**ONSITE SEWAGE DISPOSAL SYSTEM**

PROPERTY ADDRESS: 1044 Fairlane Road

SUBDIVISION: Fairlane Farms

The OSDS Plan for has been reviewed with the following comments:

LOT 21  
FAIRLANE FARM  
PHASE TWO  
RESUBDIVISION PLAT-LOTS 19 Thru 44 AND  
NON-BUILDABLE PRESERVATION PARCELS 'I' THRU 'N',  
AND REVISION PLAT-BUILDABLE PRESERVATION PARCEL 'A'  
PLATS #24367 THRU #24372  
FOURTH ELECTION DISTRICT  
HOWARD COUNTY, MARYLAND

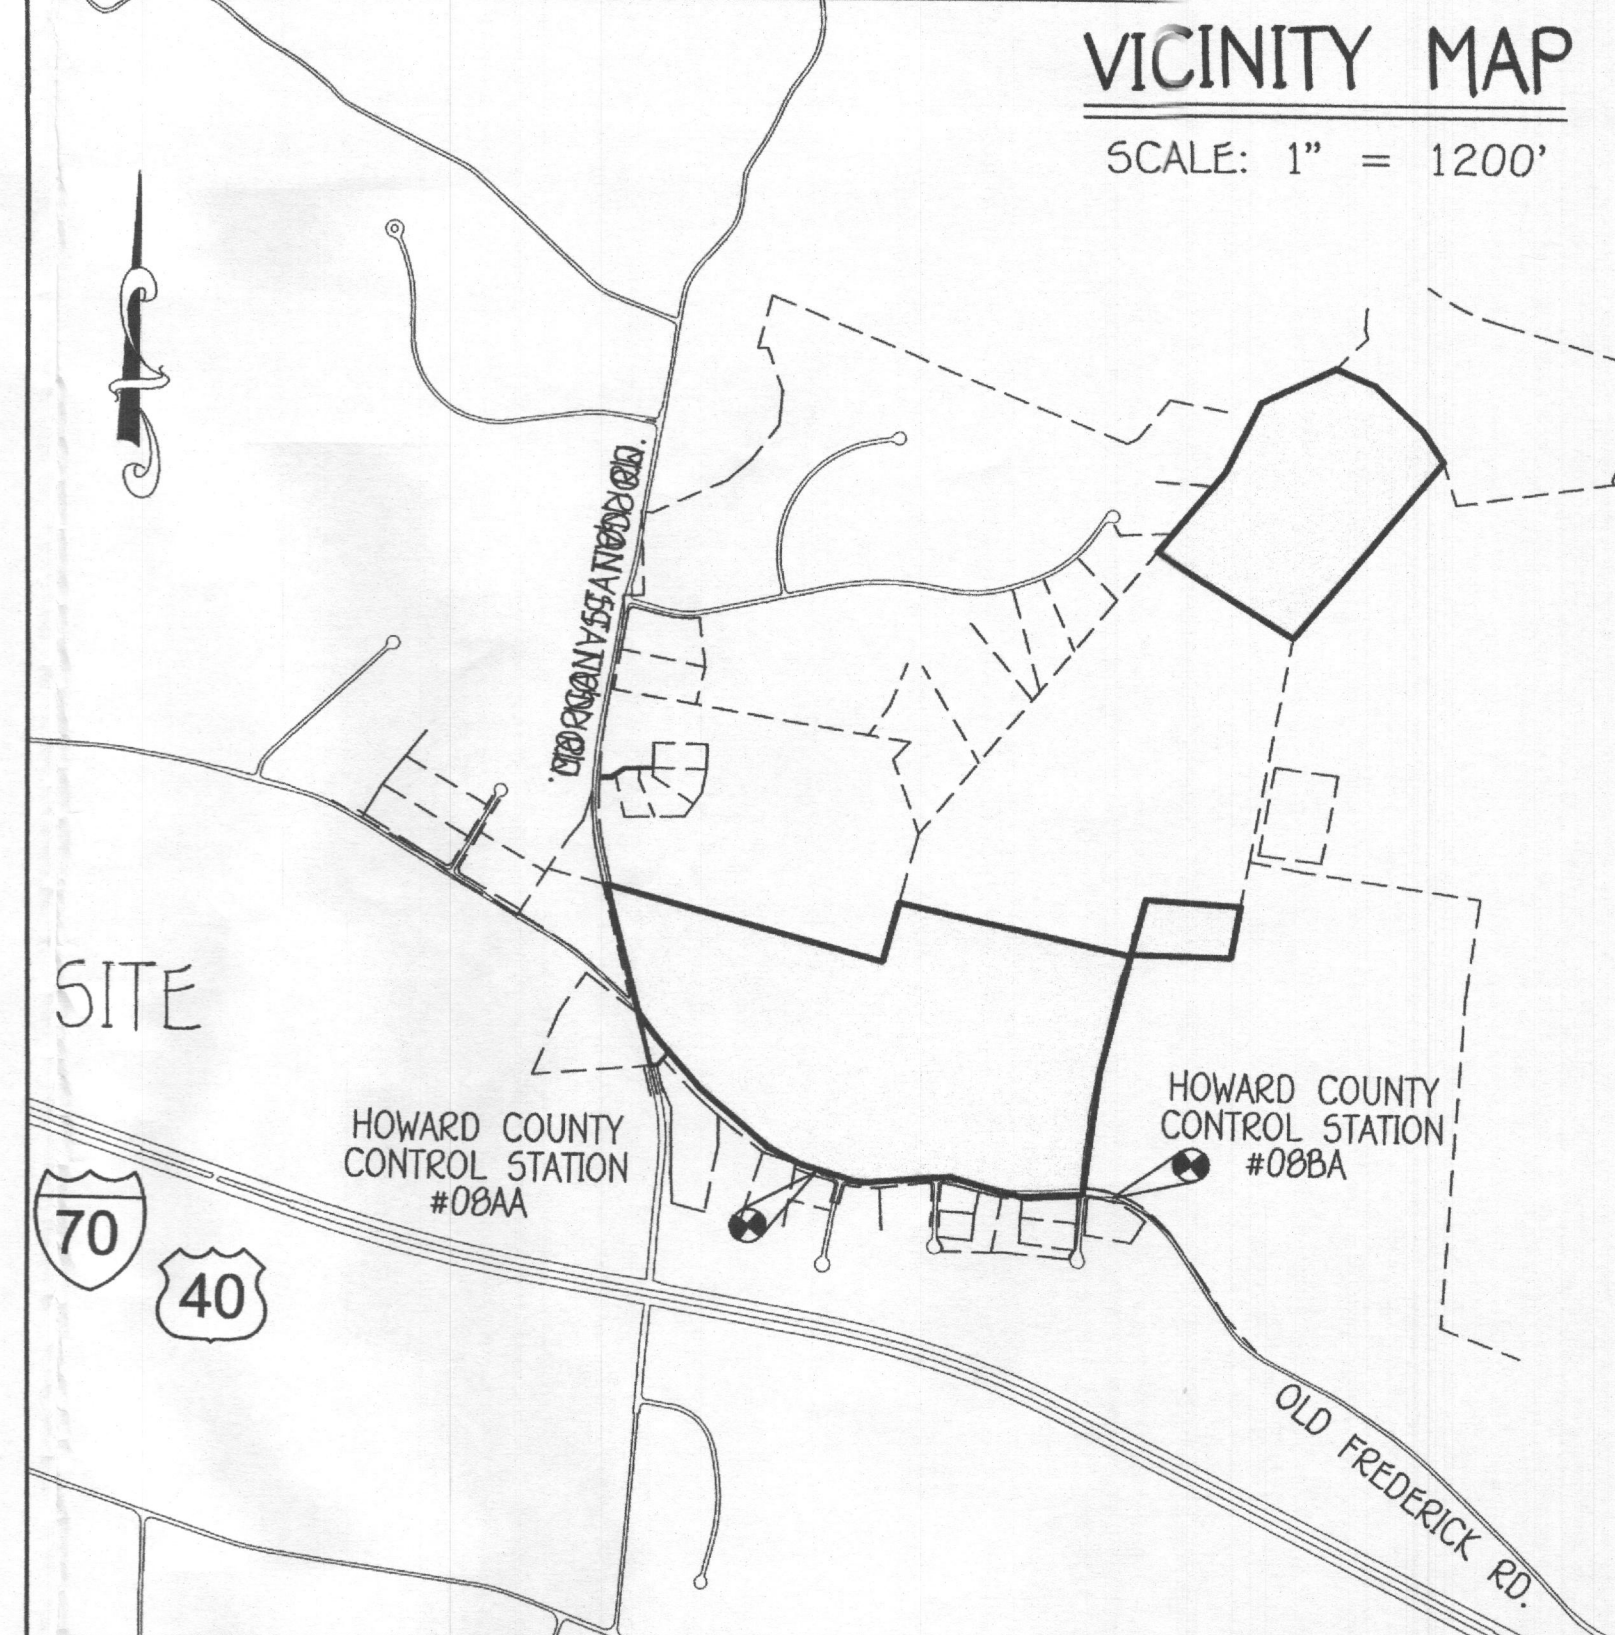
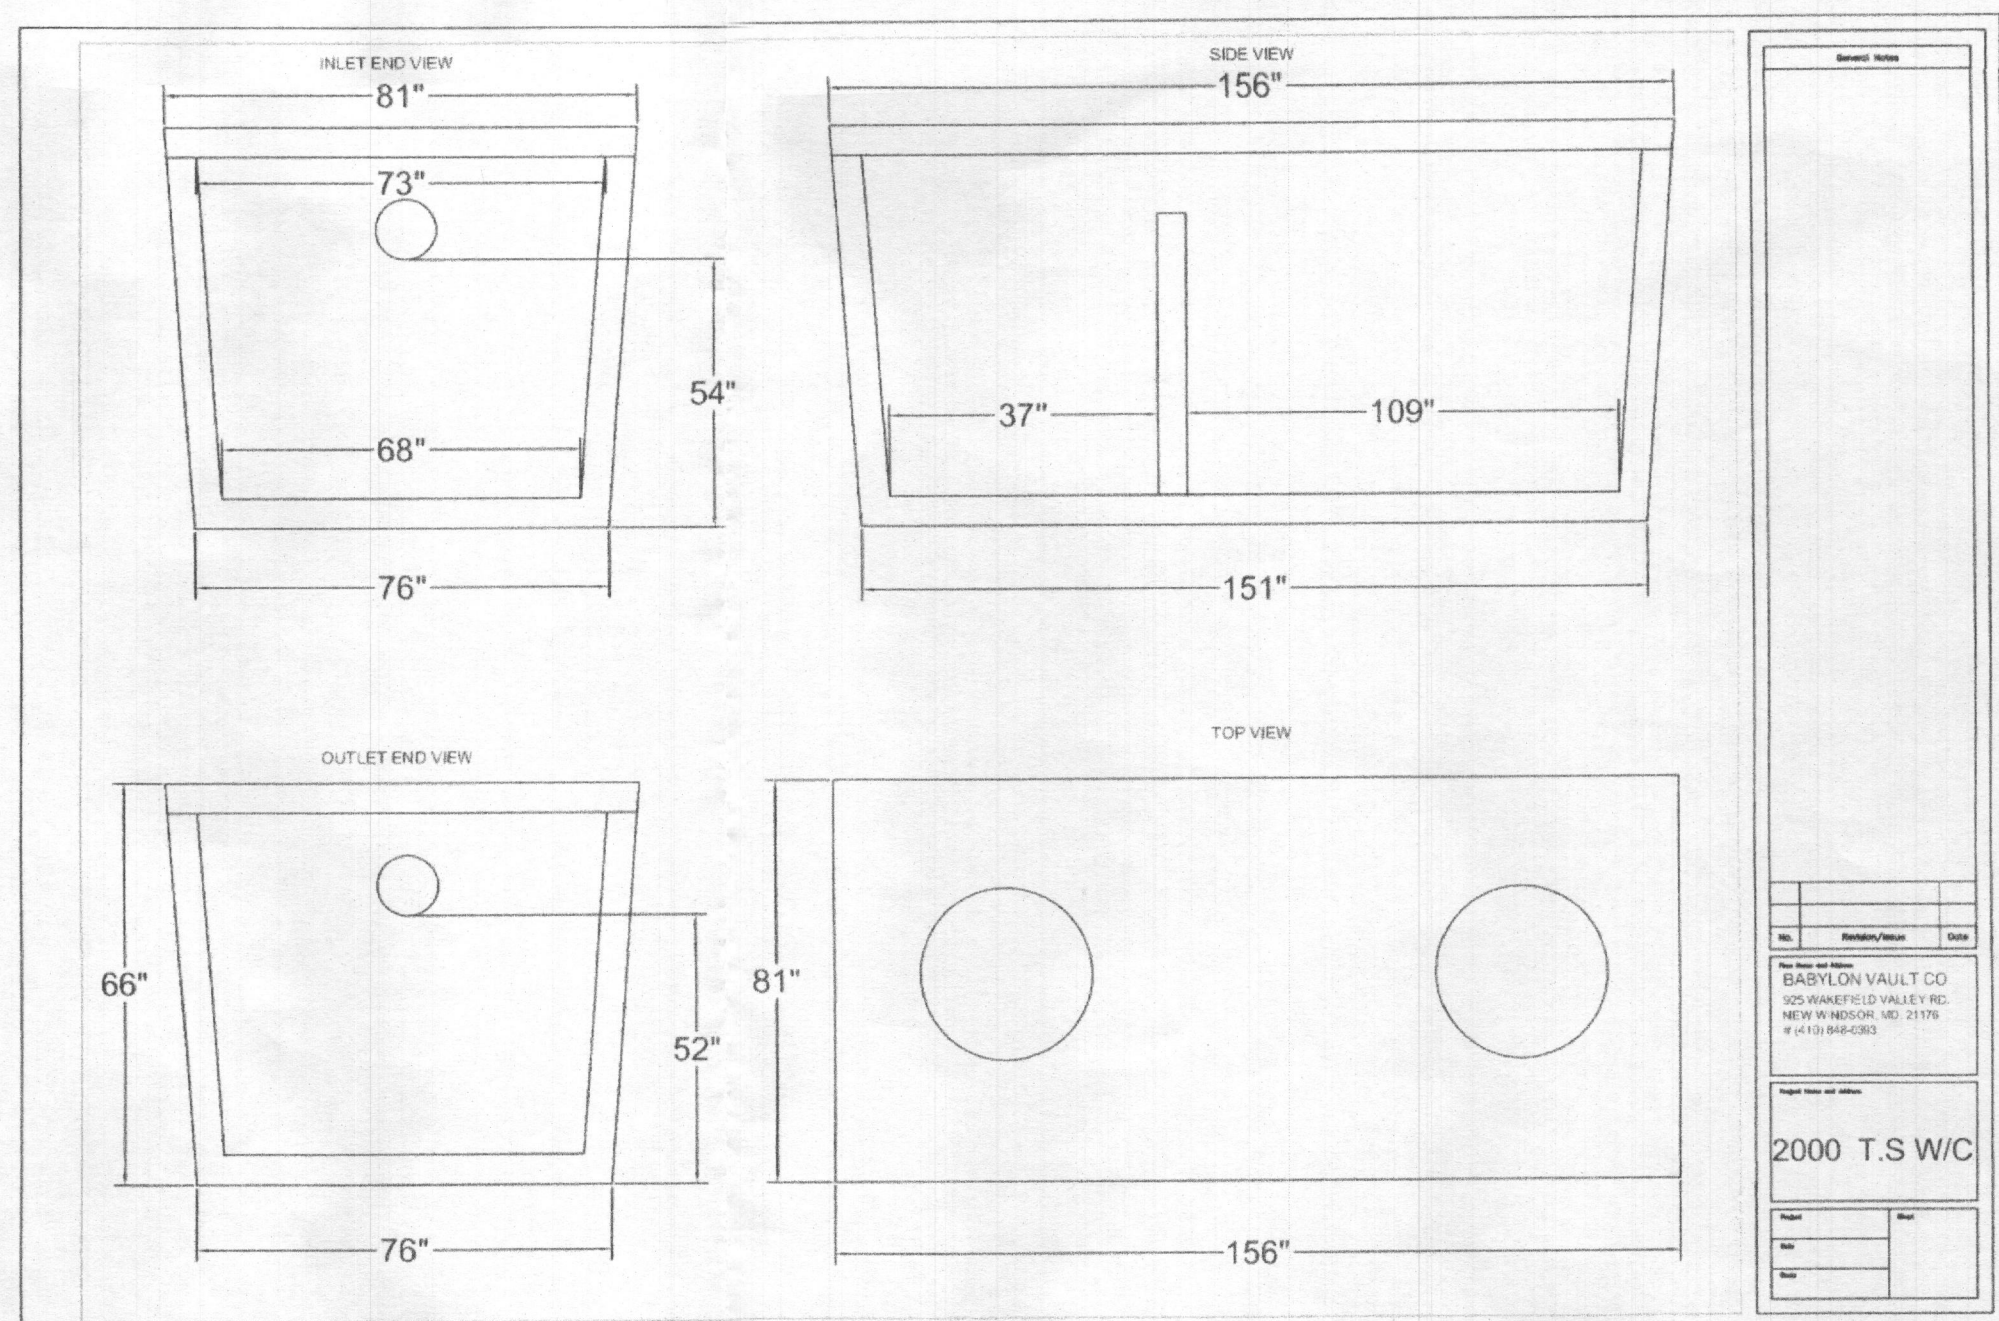
The trench I refer to is the area where the tanks were proposed in which there are two steep walls of grading going from 590 down to 586. We went out there today and that whole area is collecting water as would be expected in a large cut out area like that. The tanks were at the top of the slope within the middle of the swale/trench, but it is still a bottom area of a 4' deep cut out.

The grading proposed to achieve tanks at that location at the top corner of the SDA is not going to be acceptable in any scenario. The cut out to try to achieve that is not going to work for drainage or tank positioning. The tanks have to go somewhere else. My suggestion for where they could possibly go is shown in the attachment. That area is away from the graded swale cutting through the yard. There's minimal trees cut out to get them there and the pump would not need to be large to pump from there up to a d box. A standard 1/3 hp pump should easily handle it.

That location for the tanks is just not going to work. You're proposing to cut out too much in too little a space. You're sticking them in a big trench. Our suggestion is to propose the tanks on the bottom edge of the SDA on the other side of the graded swale and to fill in what was cut out on the side of the SDA by the shared driveway to remove that big swale.

I was looking at the layout trying to see how it could be possible to adjust the grading to be appropriate and I realized that the top corner where the septic tank is located is inside the neighbor's well arc. In order to get away from that, the tanks would have to be pushed down the side, more in the created swale, and away from the only part of the SDA that could be slightly graded to lessen a slope. There's just no way that the tanks can be up there in a swale specifically created to get the right cover over the tanks.

I don't know how the inside plumbing is oriented and how easily that could be routed out a different wall, but there is space for the tanks right at the bottom edge of the SDA by the "T" in "first replacement" on your plan. You're pumping the system anyway and then you can regrade at the top to not have a swale right next to the SDA.

Thanks for your prompt attention to this issue. I've worked on the new design based on where you and Sarah have suggested the tank locations to be. I've oriented the the sewer pipes, modified the grading (to have adequate cover over them), and have determined new elevations of the pipes and tanks. The customer was promised a rear yard that is level and usable for a pool, large deck and patio, with the walkout elevation held along the entire back wall. There has to be a drainage swale in the back yard that conveys drainage from the left side. That being said, this has been reduced in depth & I believe this will work....gravity flow from the front, where the internal plumbing drains to. Please review the attached plan and let me know is this is acceptable.

Attached is a new plan with the tanks adjusted and the grading significantly improved to lessen the slope around the tanks. The If this is acceptable, will you want to revise the SDA (require an revised Perc. Cert.)? The length of pipe from the house ends up with this plan to be a minute amount shorter in distance, and would not even change the inverts into the standard tank, or the grade over.
